DEVELOPMENT REVIEW BOARD

Parks and Recreation Department

PR-2018-001405
PS-2021-00149 – SKETCH PLAT
NUEVO ATRISCO, LLC (RON LINDSEY) requests the aforementioned action(s) for all or a portion of TRACT B, NUEVO ATRISCO zoned MX-M, located on NORTHWEST CORNER OF UNSER BLVD NW AND CENTRAL AVE NW containing approximately 3.1362 acre(s). (K-10)
PROPERTY OWNERS: NUEVO ATRISCO, LLC
REQUEST: SKETCH PLAT REVIEW

PR-2018-001405
SD-2022-01115 – AMENDMENT TO SITE PLAN
VA-2022-00165 – SIDEWALK WAIVER
DEKKER/PERICH/SABATINI | JESSICA LAWLESS agent for NUEVO ATRISCO, LLC | RON LINDSEY, DEVELOPMENT MANAGER MAESTAS DEVELOPMENT GROUP requests the aforementioned action(s) for all or a portion of: TRACT A-2 PLAT FOR TRACTS A-1 & A-2, NUEVO ATRISCO zoned MX-M, located at 201 UNSER BLVD NW between CENTRAL AVE NW and SARRACINO PL NW containing approximately 6.2231 acre(s). (K-10)
PROPERTY OWNERS: NUEVO ATRISCO APARTMENTS LIMITED PARTNERSHIP LLLP, CITY OF ALBUQUERQUE
REQUEST: NORTHERN PARCEL TO INCLUDE MULTI-PURPOSE STRUCTURE, MOBILE FOOD VENDOR COURT WITH AMENITIES, CHILDRENS ACTIVITY AREA, WATER FEATURE, PERIODIC FARMERS MARKET, SOUTHERN PARCEL TO CONTAIN 5,000 SQ FT RETAIL/ RESTAURANT WITH POSSIBLE P

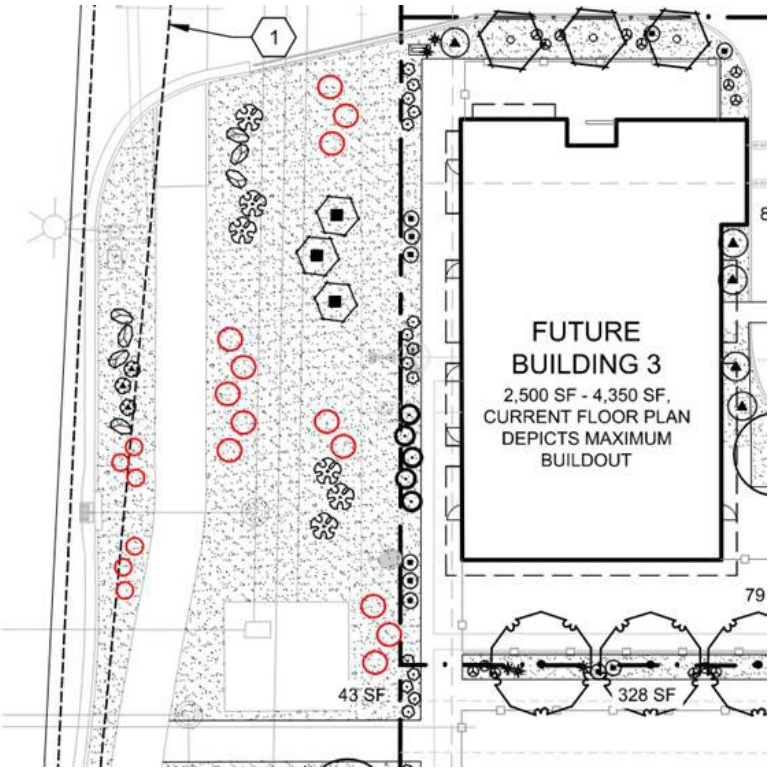
In an email dated 07-12-2022, DPS Landscape Architect sent the below graphic indicating additional shrubs on Central Avenue. Please update the Landscape Plan for the project to reflect additional shrubs before final signatures (delegation is acceptable).
